Well Name: HUERFANO UNIT

Subsequent Report

Type of Action: Plug and Abandonment

HILCORP ENERGY COMPANY
HUERFANO UNIT 28
P&A NOI

Current Schematic - Version 3

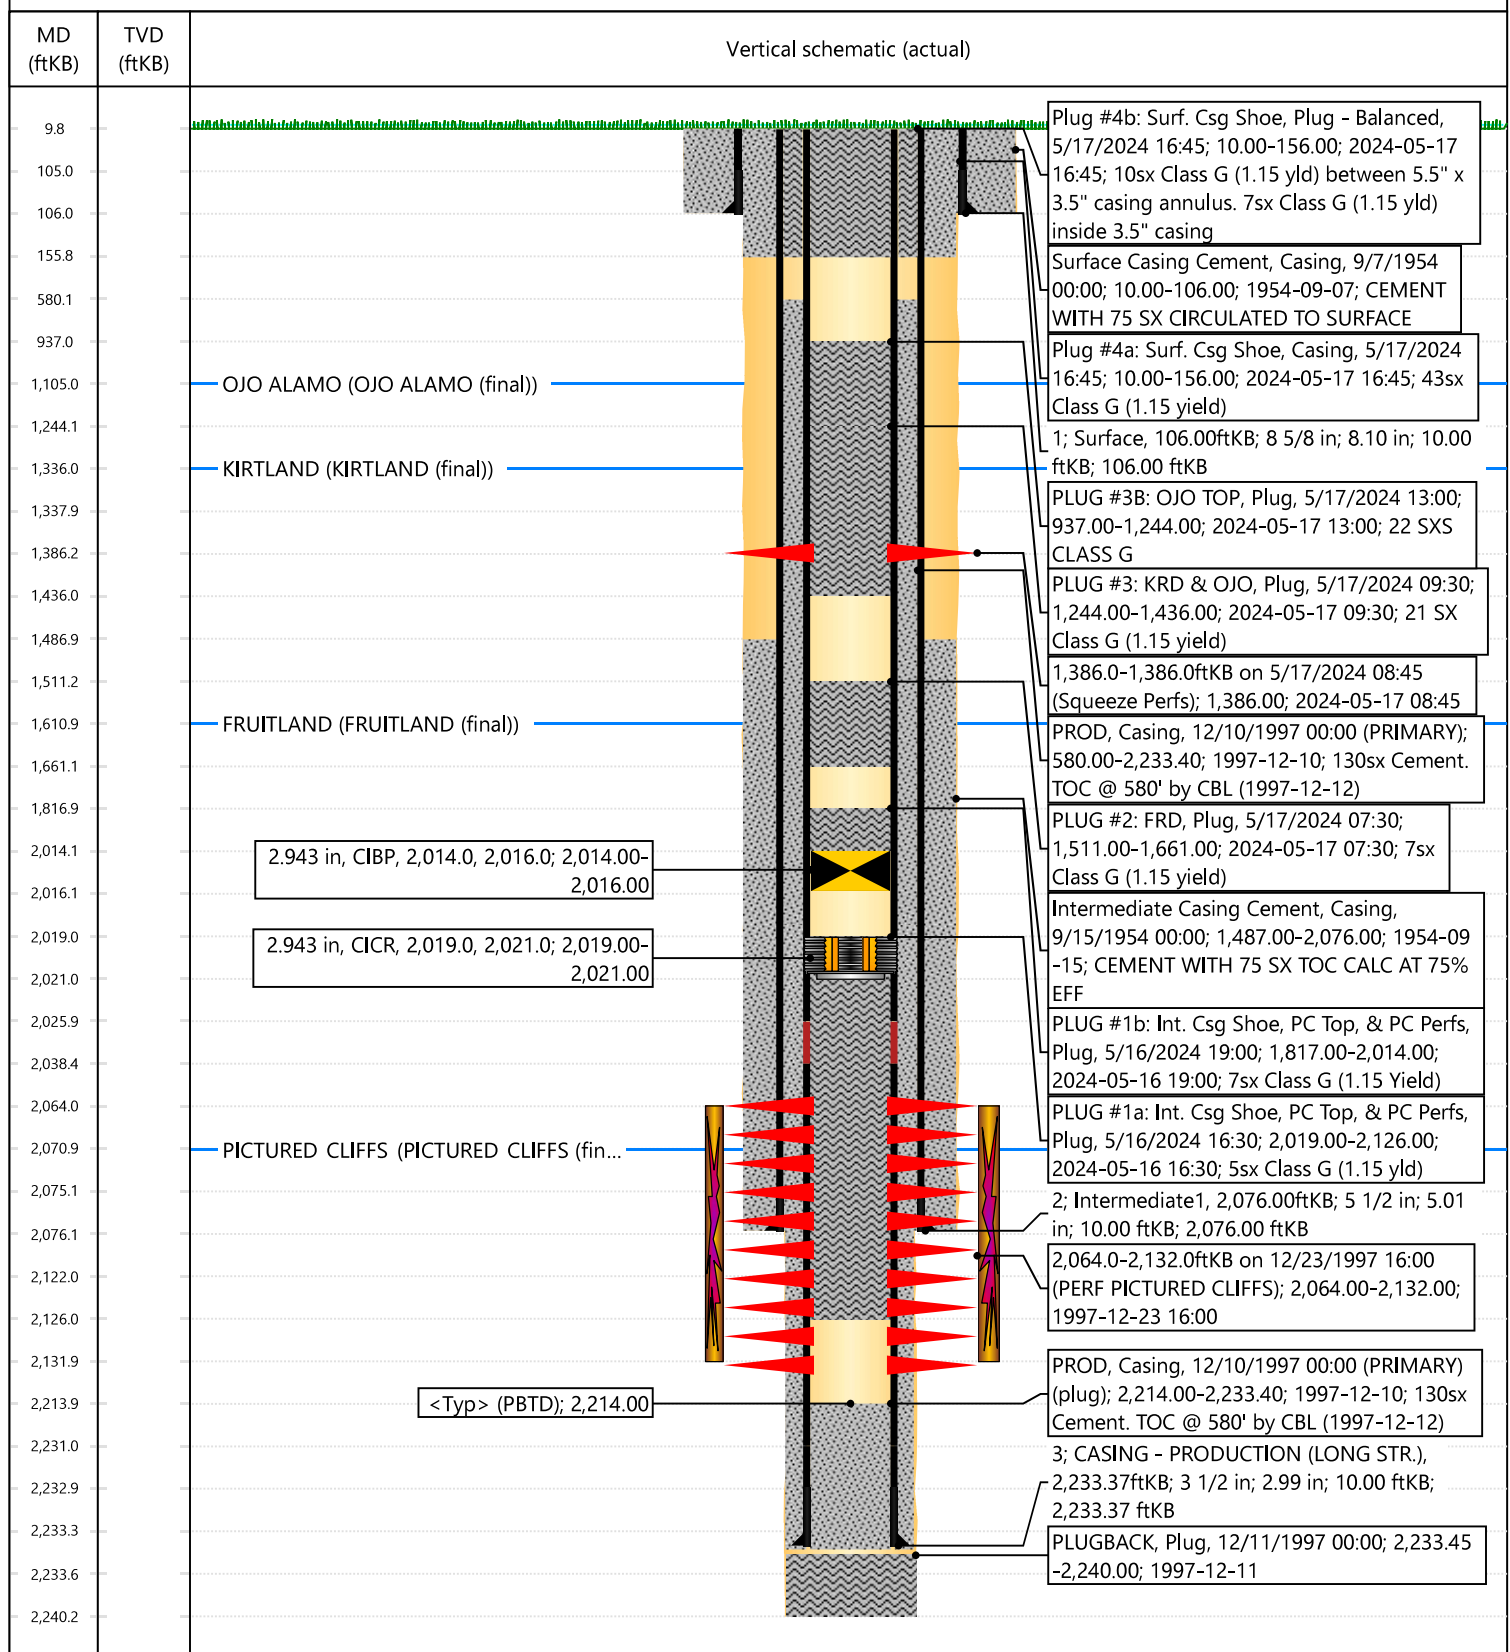
The BLM finds this procedure, with the corrected diagram, appropriate.

- PLUG #1a: The CICR will be set at 2,024' (Int. Surface Shoe @ 2,076', PC Perfs @ 2,364', PC Top @ 2,371'). **(NMOCD provided verbal approval for this after discussing the depths compared to the original COAs)**
 - Pump 102' of cement beneath the CICR from 2,024' to 2,126' (50' beneath the intermediate shoe).
- PLUG #1b: The CIBP will be set at 2,014' (Int. Surface Shoe @ 2,076', PC Perfs @ 2,364', PC Top @ 2,371') as stated in the original NOI. **(NMOCD provided verbal approval for this after discussing the depths compared to the original COAs)**
 - Pump 150' of cement on top of the CIBP from 1,864' to 2,014'.
- All other plugs have been adjusted according to the BLM & NMOCD formation tops. Please see the revised procedure attached and below.

The BLM has no issues with perforating at 156'.

Thank you for bringing that to my attention. We will plan to perforate at **156'** instead of 408' and circulate to surface. The 408' perf depth is no longer necessary since the BLM determined the NACIMIENTO to be at surface.

NMOCD approves below with exception – If circulation to surface is not achieved at perforation at 408 feet – perforating at 156 feet will be required.
